Department of Planning and Zoning

MEMORANDUM

To: Development Review Board
From: Mary O'Neil, AICP, Senior Planner
Date: September 3, 2013
RE: ZP 14-0035CA; 121 North Willard Street

Request: Convert 2nd floor of existing carriage barn into a one bedroom apartment; increasing the number of residential units on the site from one to two.

121 North Willard Lot Coverage

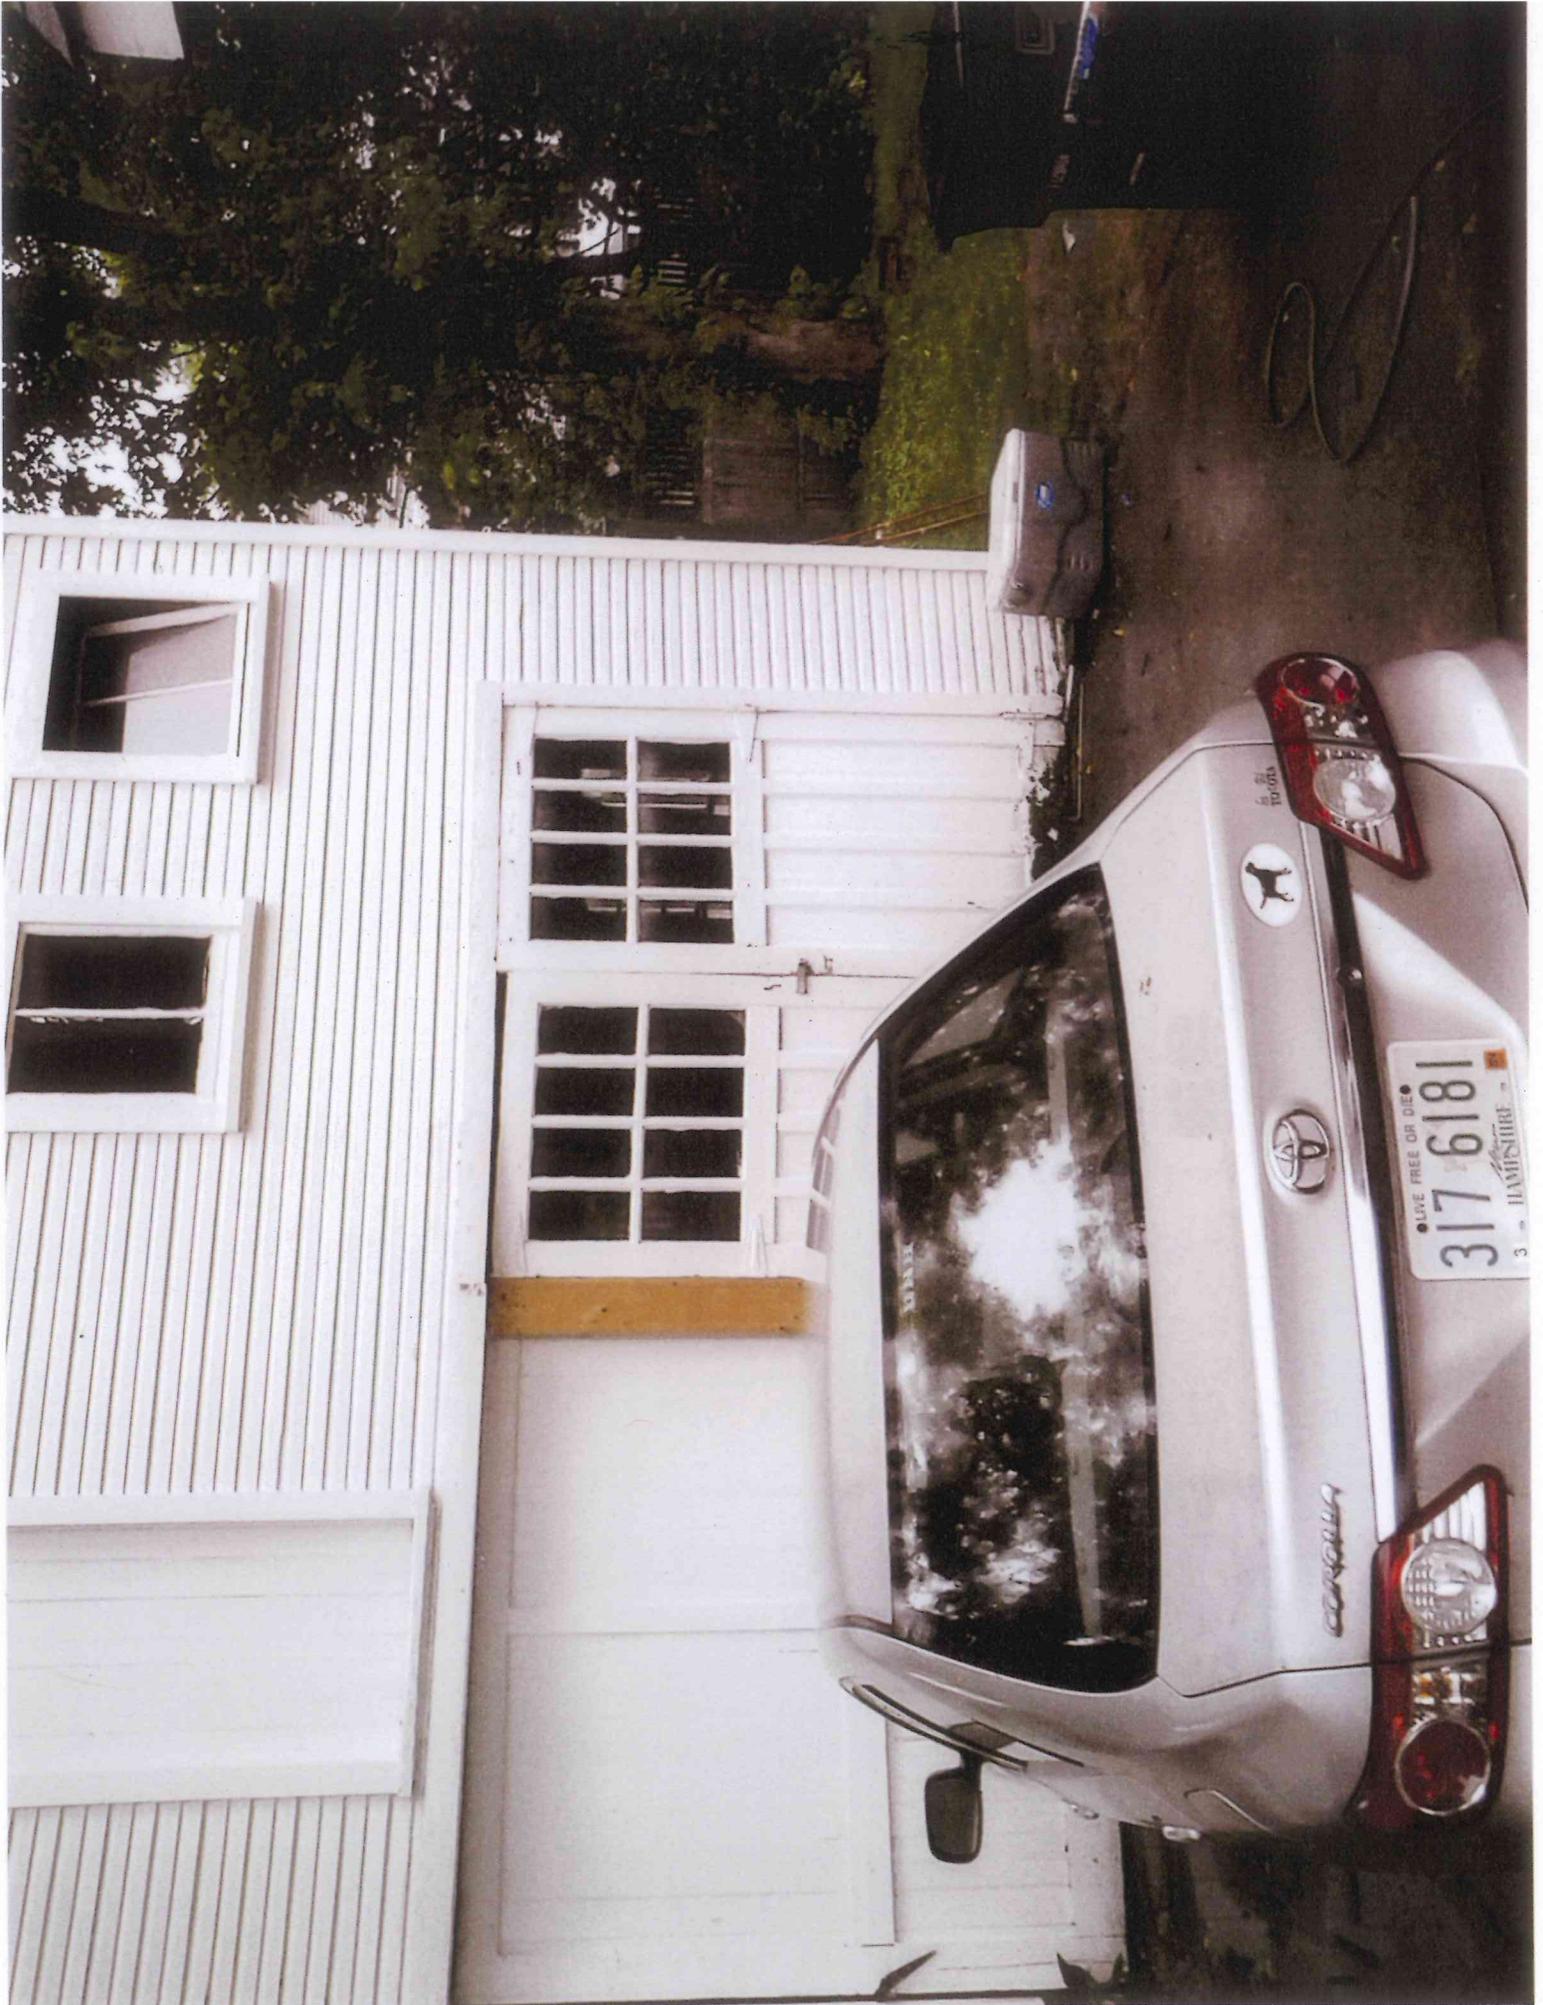
5. Lot coverage shall not exceed existing, non-conforming level. **Prior to release of the zoning permit**, final coverage calculations shall be submitted that confirm no increase in the level of nonconformity. The proposed new rear canopy shall be included on that plan.

① EAST ELEVATION
 1/4" = 1'-0"

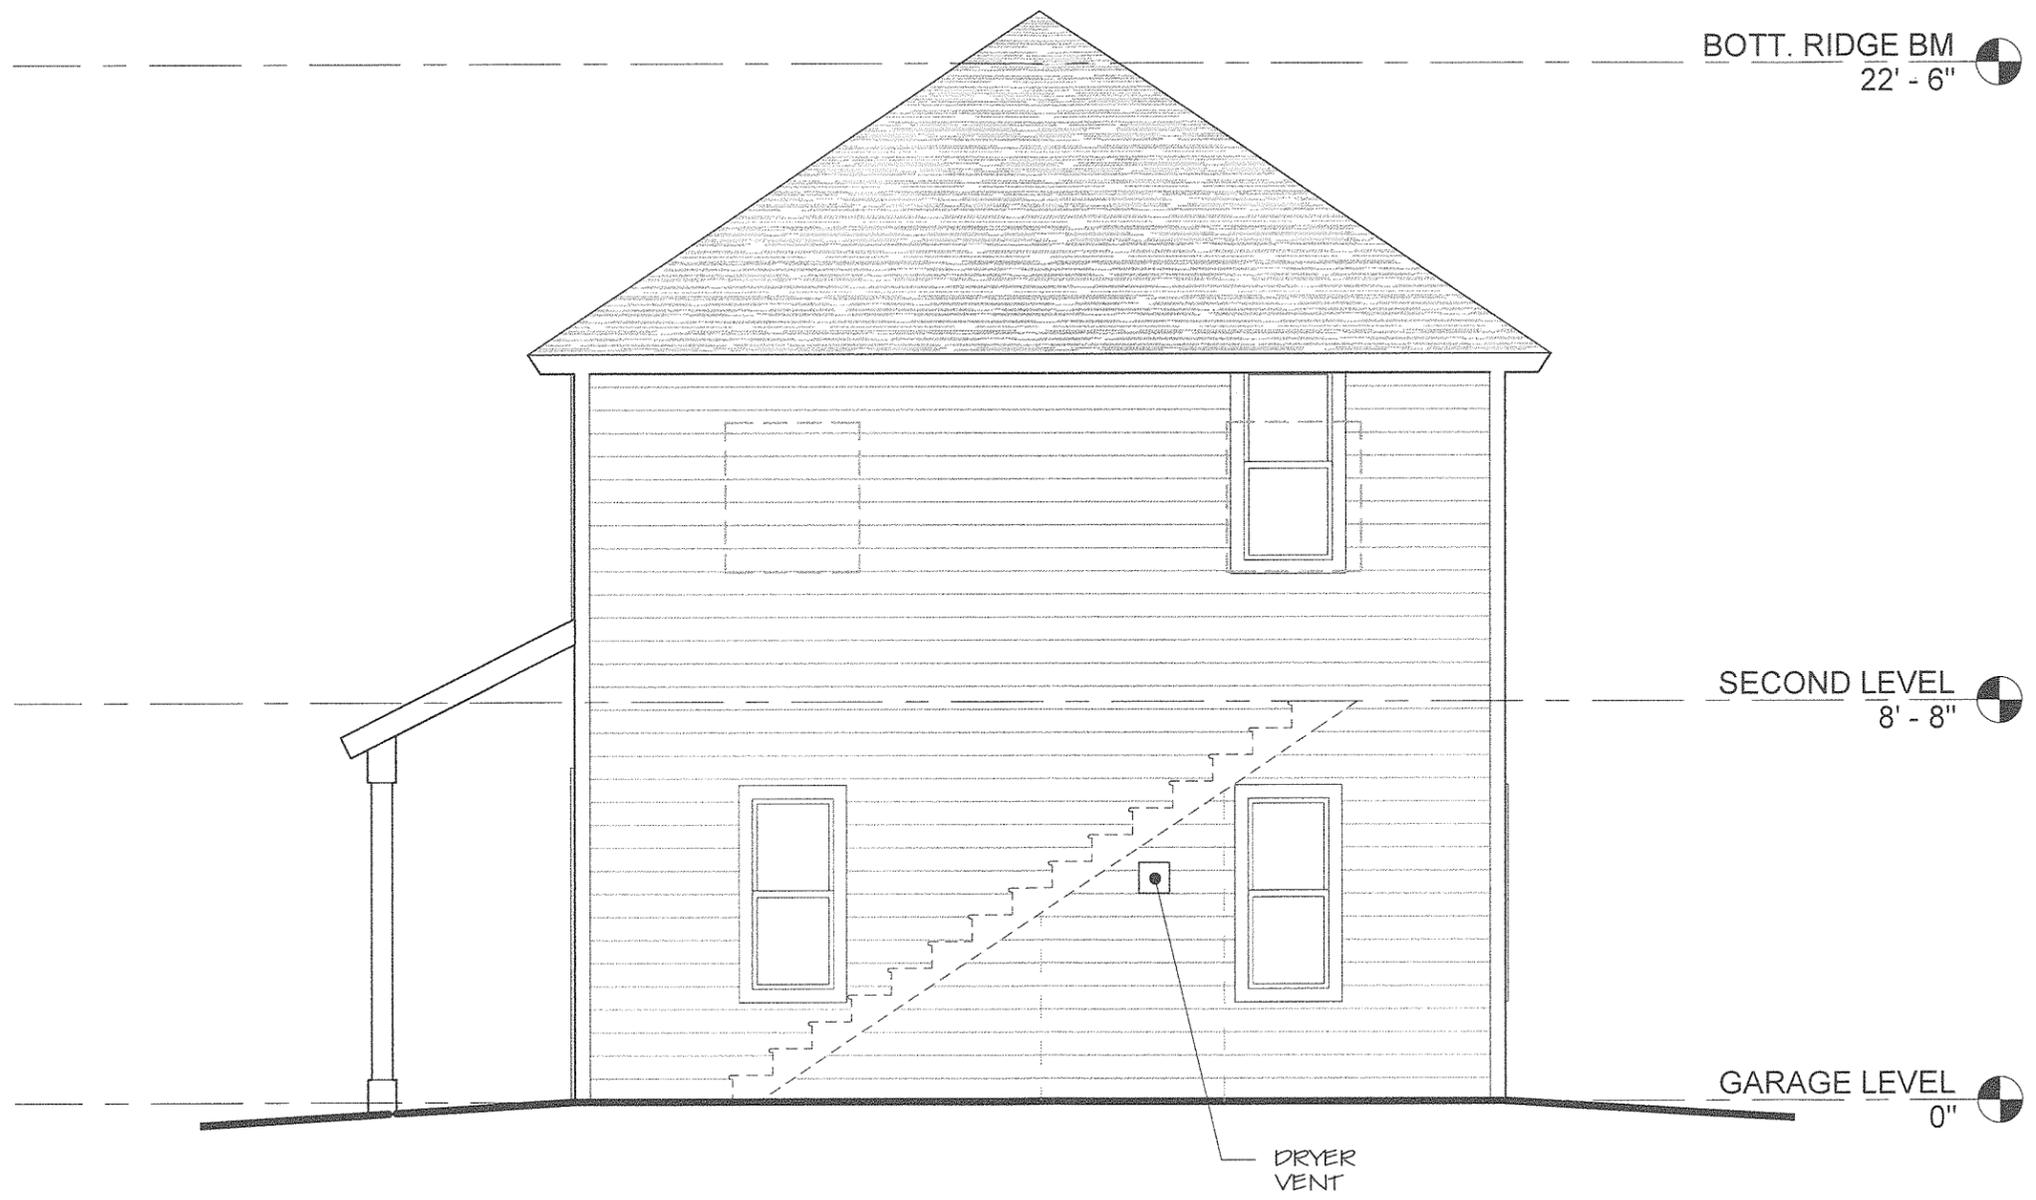
1. We approve the changes the applicant has made in the revised elevations noted as Plan A-4 reflecting original fenestration:
 - a. Two 2 lite (side by side, as existing) awning style windows, and
 - b. Large window over garage door.
 - c. Covered entryway over (pedestrian) door (Plan A.5)
 - d. Intent to further minimize coverage with tire track driveway. Revised site plan and coverage calculation will be required.
 - e. Retention of the block and tackle is recommended.
2. We recommend the paneled garage door be repaired.
3. The location of trash needs to be defined.

The original garage use is proposed to be continued; however 2nd story storage space will be converted to residential use. Revised elevations submitted to the Design Advisory Board show deference to the original arrangement of building openings, with retention of the upper storage window bay and smaller 2-light windows over the garage bay doors. Window alterations on secondary facades are anticipated and acceptable. The DAB has conditioned their approval on insertion of simulated 2 light (side by side) sash in the front awning windows to replicate the existing. **Affirmative finding as conditioned.**

While some alteration may be anticipated on side and rear elevations, the primary (east) elevation should be respected with window installation that respects the existing configuration. Revised elevations have demonstrated that. Cornice line trim should be retained as well. **Affirmative finding as conditioned.**

2. Awning windows on the east elevation shall visually replicate the 2 light sash that currently exists, per direction of the Design Advisory Board. If simulated divided light, muntins shall be factory adhered on the exterior to create shadow lines and visually replicate the existing window pattern.

1 WEST ELEVATION
1/4" = 1'-0"

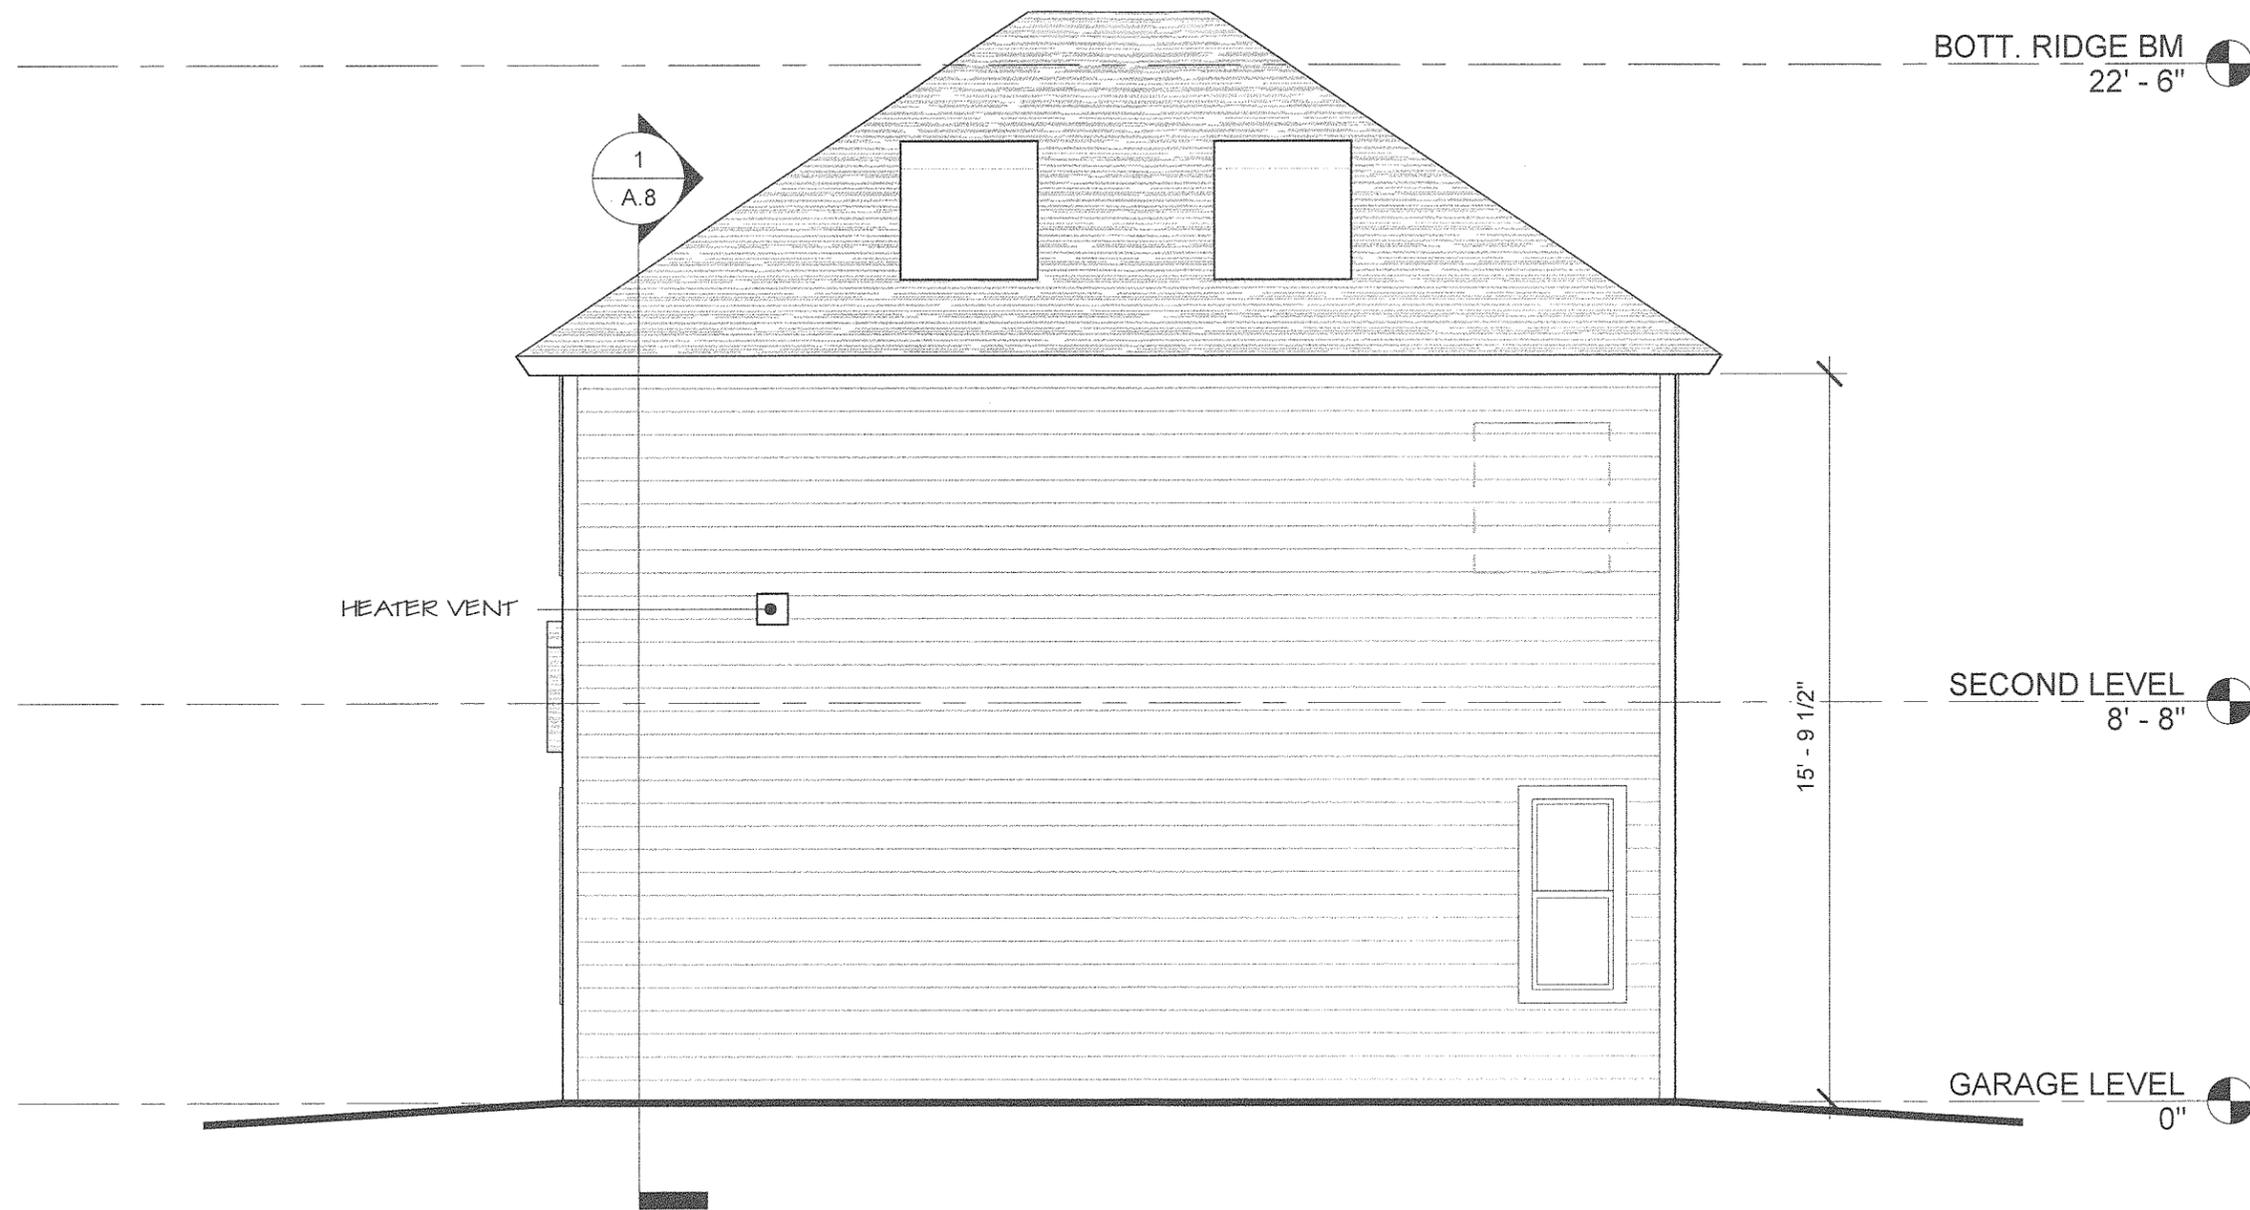
A rear setback is required in this zoning district; however the carriage barn is an existing structure. It does not appear from the submitted site plan that the building enjoys a minimal 5' setback from either the south or west property lines; quite to the contrary, it sits close to the boundary line. The west elevation (as proposed) includes new windows at both levels; on the south elevation, skylights are included. Depending upon the specific distance to the property line, windows there may not be permitted. This building code issue should be reviewed by the building inspector for acceptability and compliance with building and life safety code. Additionally, the windows proposed on the west elevation will be in immediate and proximate view of the abutting rear neighbor, and will provide very little privacy for either.

Review of the appropriateness of these window openings relative to building code by the building inspector will be a condition of approval. **Affirmative finding as conditioned.**

1. To retain the character of the historic carriage barn, principle openings on the east elevation (front) should remain as existing. New window infill may occur within those openings. Windows on secondary facades may be altered with greater flexibility, and with the approval of the building inspector. Window replacement or new installation along the south and west facades of the carriage barn shall be reviewed by the building inspector for appropriateness of distance and conformance to building code.
